Urgent Field Safety Notice **IPPB Flextube™ breathing system**

Urgent Field Safety Notice (FSN)

IPPB Flextube™ breathing system

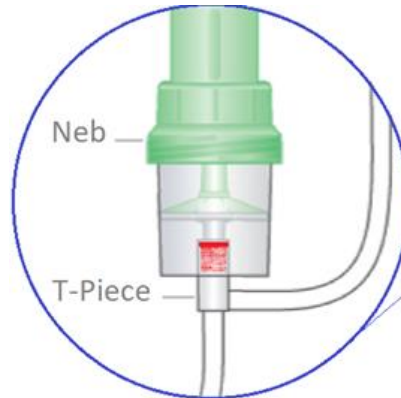
2 Reason for Field Safety Corrective Action (FSCA)*	
2.	<p>1. Description of the product problem*</p> <p>1. We have received a report of loose connections between the nebuliser and supply line T-Piece in one of our IPPB breathing systems (see figure1 below). When the system is pressurised, there is the possibility that the T-Piece can detach from the nebuliser. See Actions 1. and 2. in Sec. 3.1 below.</p>  <p style="color: red; text-align: center;">Red shows loose connection</p> <p>Figure 1: IPPB Breathing system schematic showing zoom detail of nebuliser and supply line T-Piece connection</p> <p>2. In the case of Ref: 1416000, which is supplied with the nebuliser supply line and t-piece as a separate accessory (not already connected); the risk is lower as it will be attached to the nebuliser before use where required, and a push and twist action must be used to ensure a secure connection, as per the instructions for use provided. This action will identify a loose connection.</p> <p>3. As a result of the reported problem, we have identified the opportunity to improve the current Instruction For Use provided with these products. The Pre-Use Checks section will in future include the following warning;</p> <p><i>“WARNING: Every component of the breathing system must be visually inspected and checked for function, leakage and occlusions, immediately before use on each patient. Ensure that connections are secure using a push and twist action.”</i></p> <p>See Action 2. In Sec. 3.1. below.</p>

2.	<p>2. Hazard giving rise to the FSCA*</p> <p>The disconnection of the nebuliser/ exhalation valve control T-Piece during use would cause a minor delay or interruption of treatment.</p> <p>As the issue has been shown to occur immediately at set-up or very shortly after first use, a clinician will be present. If a secure reconnection cannot be achieved, a replacement product will be needed to continue treatment.</p> <p>A short delay or interruption to treatment will result in an extended procedure time, which has been evaluated as a minor risk</p>

1. Identify any potentially affected products from the affected codes and lot numbers listed above.
2. The security of connection between the Nebuliser and T-Piece can be checked by hand through the packaging. Secure connection should be possible using the push and twist action as detailed in the device Instructions For Use.

Additionally to the current instructions for use, you must confirm a secure connection can be achieved between the nebuliser and gas supply, using a push and twist action. This new instruction is currently being added to the IFU for the future.

2. If using the Nebuliser Supply Line and T-Piece accessory provided in a separate bag with Ref: 1416000, ensure a secure connection is achieved when connecting the T-piece to the nebuliser with a push and twist action as per the instructions for use provided.
3. If a secure connection cannot be achieved with a device, remove from use, quarantine the product and please return to us immediately.
